SA14-2056-01  
(IBM Order Number)

9/96  
REV 1

## Addendum to PowerPC 604™ RISC Microprocessor User's Manual: **PowerPC 604e™ Microprocessor Supplement and User's Manual Errata**

**3.4.2 General Comments on 604 Snooping**

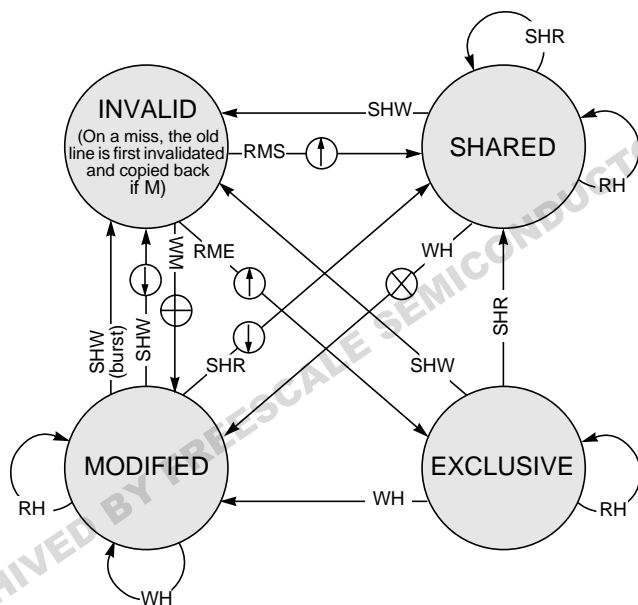
3.4.2, Page 3-8      Add the following section:

When a 604 is not the bus master, it monitors all bus traffic and performs cache and memory queue snooping as appropriate. The snooping is triggered by the receipt of a qualified snoop request, as indicated by the simultaneous assertion of the transfer start ( $\overline{TS}$ ) and the global ( $\overline{GBL}$ ) bus signals. The only exception to this qualified snoop request is for four address-only transactions; the 604 also snoops its own TLB invalidate, TLBSYNC, SYNC, and ICBI transactions regardless of the global ( $\overline{GBL}$ ) bit setting.

The 604 drives two snoop status signals,  $\overline{ARTRY}$  and  $\overline{SHD}$ , in response to qualified snoop requests. These signals provide information about the state of the addressed block with respect to 604 for the current bus operation. These signals are described in more detail in this document. The following additional comments apply:

- Any bus transaction that does not have the  $\overline{GBL}$  signal asserted can be ignored by all bus snoopers. All such transactions, except the self-snooping transactions, are ignored by the 604.
- Several bus transactions (write with flush, read, and read with intent to modify) are defined twice, once with the TT0 reset and once with it set (for atomic operations). These operations behave in exactly the same manner with respect to bus snooping.
- The receiving processor may assert  $\overline{ARTRY}$  in response to any bus transaction as a result of internal conflicts that prevent the appropriate snooping.
- The receiving processor may clear its reservation due to snoop address hit with several bus transactions (write-with-flush, read-with-intent-to-modify, write-with-kill, and kill). The reservation is clear even if the 604  $\overline{ARTRY}$ s the particular bus transaction.

**Figure 8-20. Burst Transfers with Data Delay Controls**

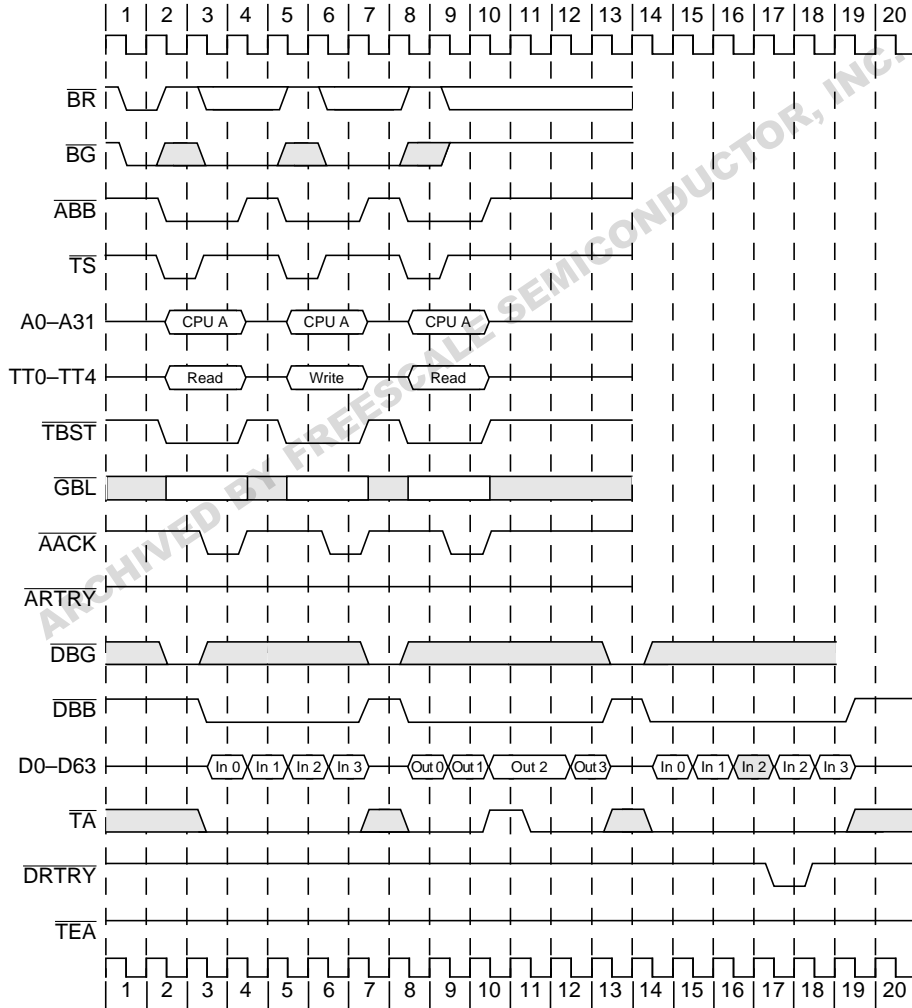
8.5, Page 8-36      Replace Figure 8-20 with the following:

**Figure 8-21. Use of Transfer Error Acknowledge (TEA)**

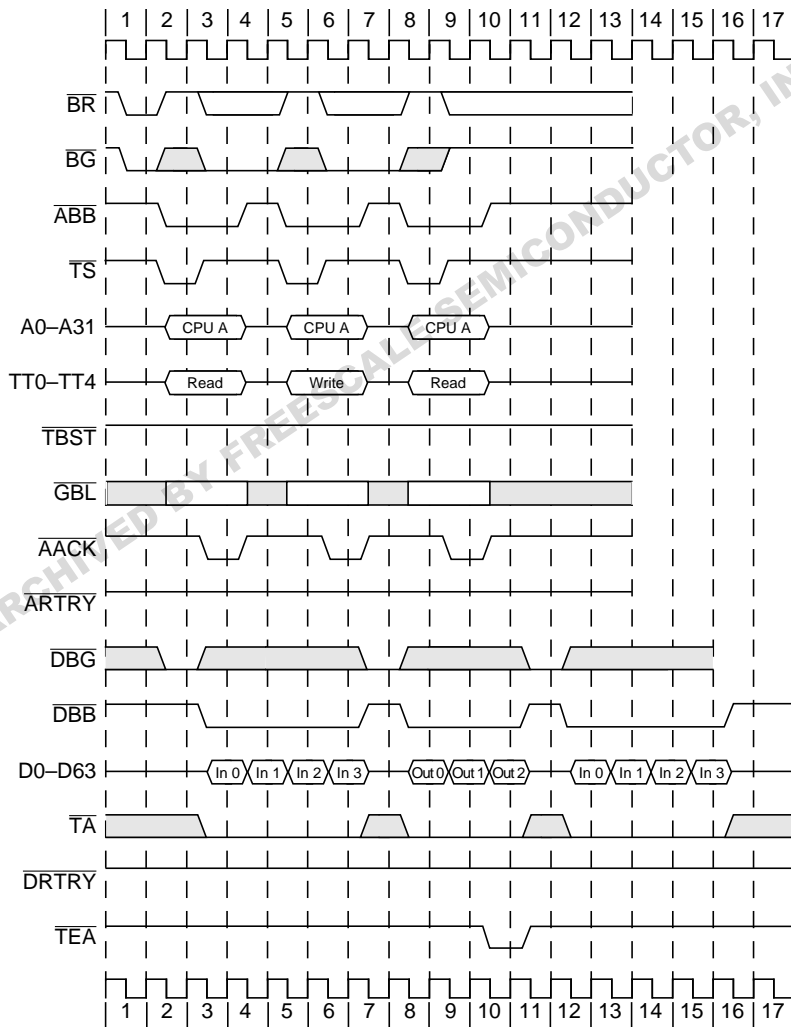
8.5, Page 8-37      Replace Figure 8-21 with the following:
